Addendum 15 – UN Regulation No. 16

Revision 8 – Amendment 5 - Corrigendum 1

Corrigendum 1 to Supplement 9 to the 06 series of amendments – Date of entry into force:
20 June 2018

Uniform provisions concerning the approval of:

"Figure 2

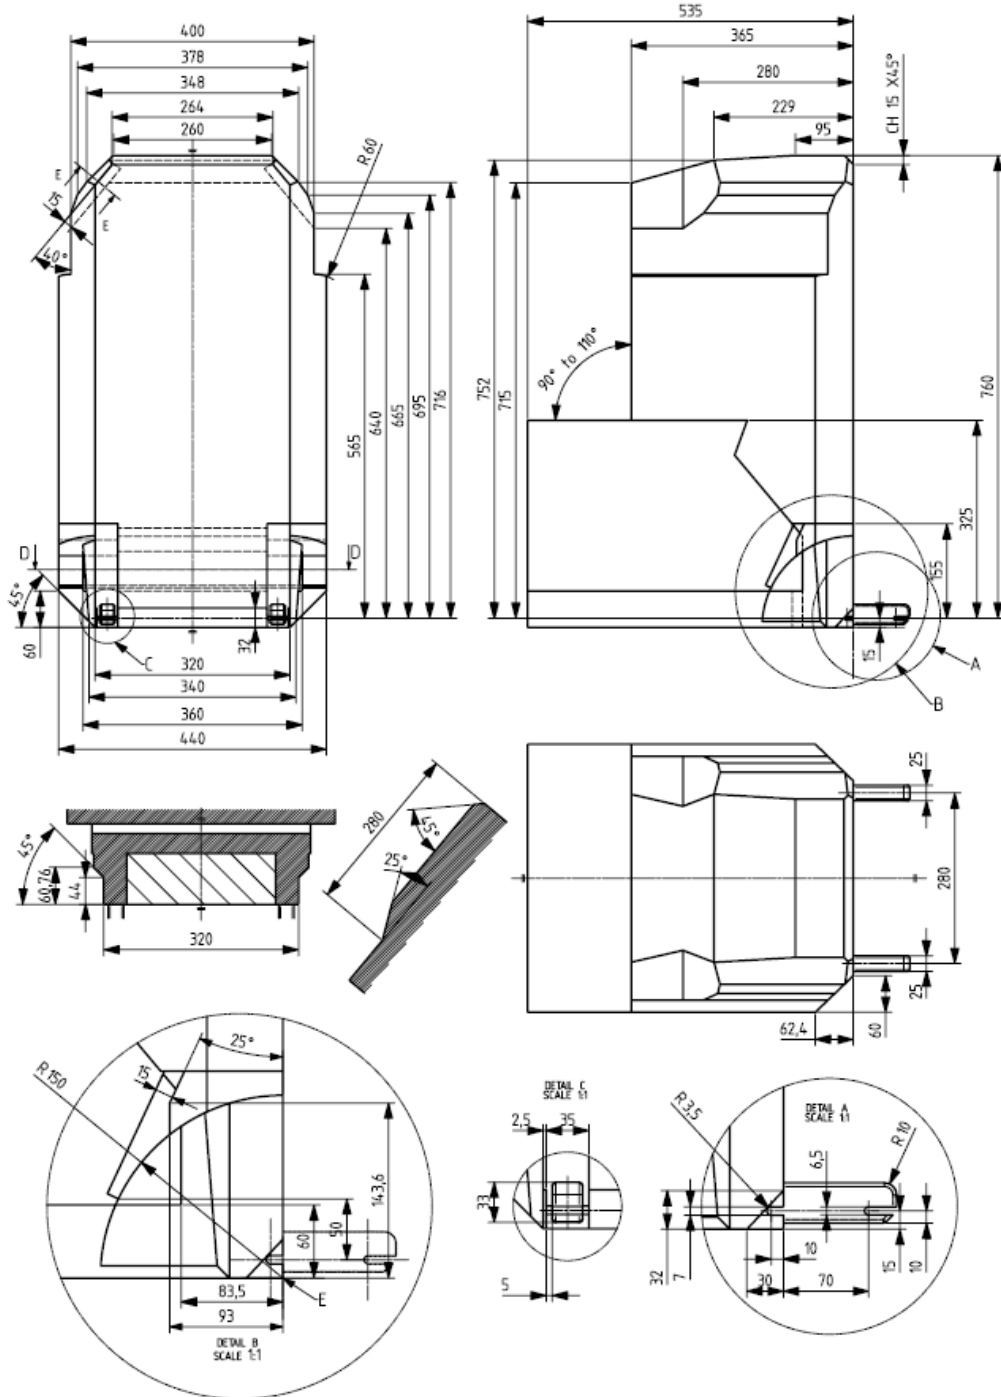
Appendix 5, figure 2 ISO B2, to be replaced as follows:

"Figure 3

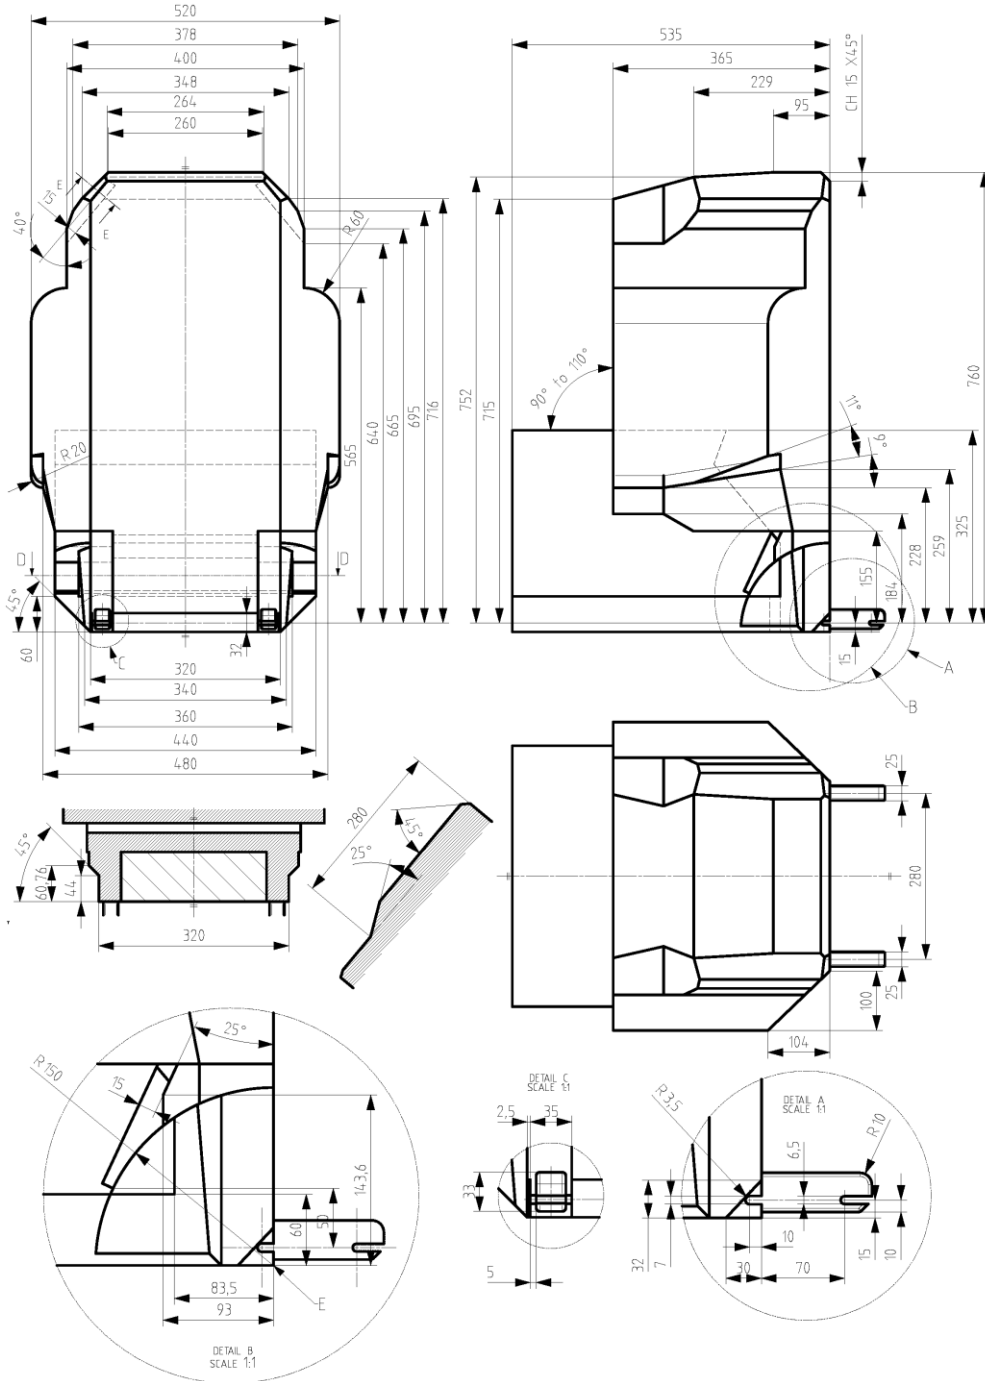
Appendix 5, Figure 3 ISO/B3, to be replaced as follows:
